**MODEL A-30 ALTITUDE ENCODER AND MODEL E-01 ELT
CONTINUING AIRWORTHINESS REQUIREMENTS**

Service Bulletin SB E-01.3

Service bulletin SB E-01.6

SERVICE BULLETIN SB E-01.9
December 12, 2006
MODEL E-01 ELT AFFECTS ALL SERIAL NUMBERS

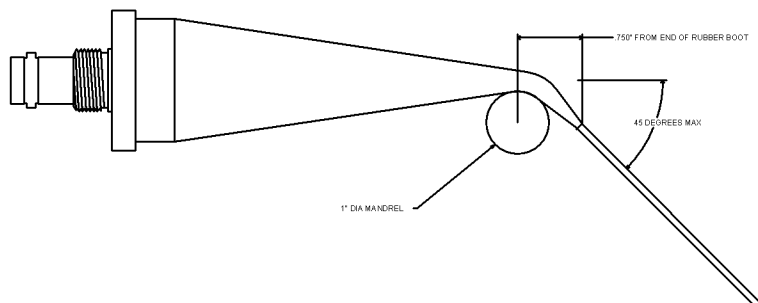
The Antenna supplied with the Model E-01 ELT part number E0115 is not recommended for use above 250 Knots and should not be used on aircraft certified for known icing. The antenna may be bent as shown below to facilitate installation.

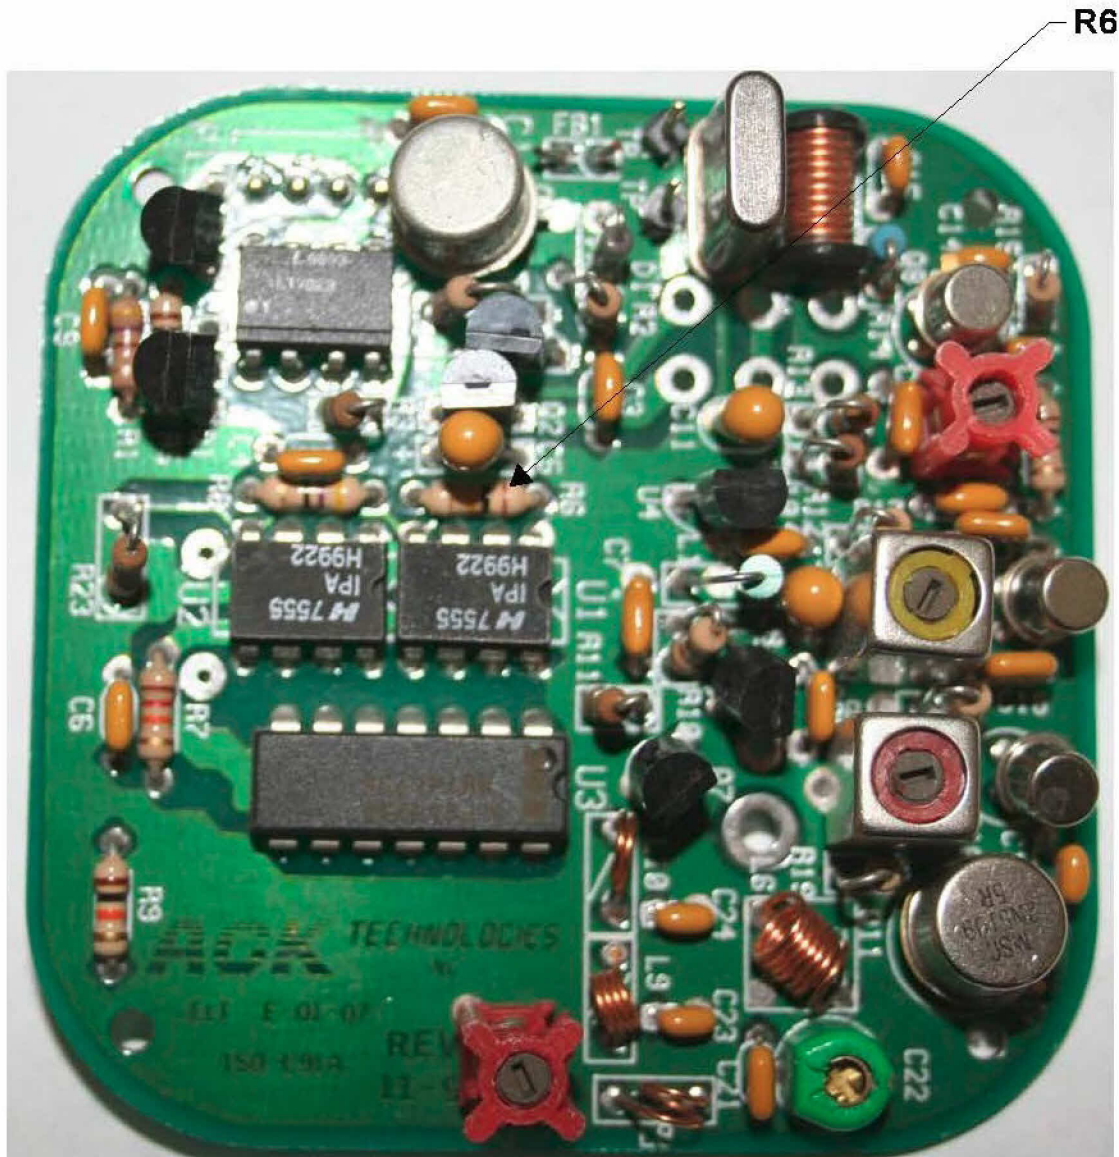
1. When installing the bottom four batteries in the battery case always lubricate the outside of the batteries with a light coat of paste wax, mild soap solution or silicon vacuum grease. Also lubricate the "O" ring at this time.

2. Install all four of the bottom batteries at the same time to the same depth. (see Fig 1)
3. Do not install three of the batteries to full depth and force the fourth battery into place as this can cause tearing of the battery insulating cover (See Fig 2)

4. Push the bottom four batteries down into position at the same time using the top four batteries (See Fig 3)
5. Place the "O" ring into position and position the transmitter section of the ELT on the bench top with the RCPI cable at the edge of the bench top and push down as far as possible. Install the four battery retaining screws and evenly tighten them until the battery case is snug against the transmitter assembly. Torque the screws to 3.5 – 4.0 in/lbs do not over tighten. (See Fig 4)

Figure 1

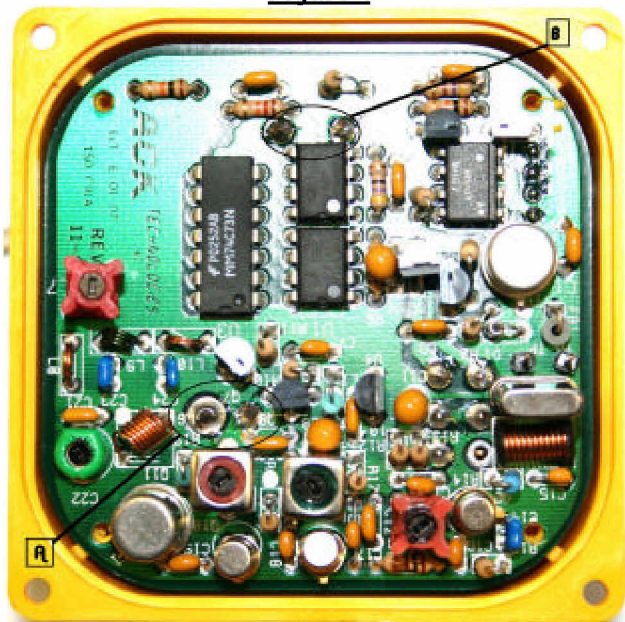
- 5.) Remove the 4 small Philips head screws in each corner of the circuit board.
- 6.) Locate and heat B&C connector and ground (Figure 1, Example A) while pushing on/off toggle switch to remove circuit board from component housing.

- 7.) De-solder B&C connector ground wire, and replace with new 3in. 20-22 gauge tinned copper wire.
- 8.) Remove 4 wire plug.
- 9.) De-solder G-switch noting lead positions. (Figure 1. Example B)

- 15.) Re-assemble head unit aligning "Final" stamp (Figure 2, Example C) on each half of the casing, and place long brass index nut as positioned in Figure 2, Example D.
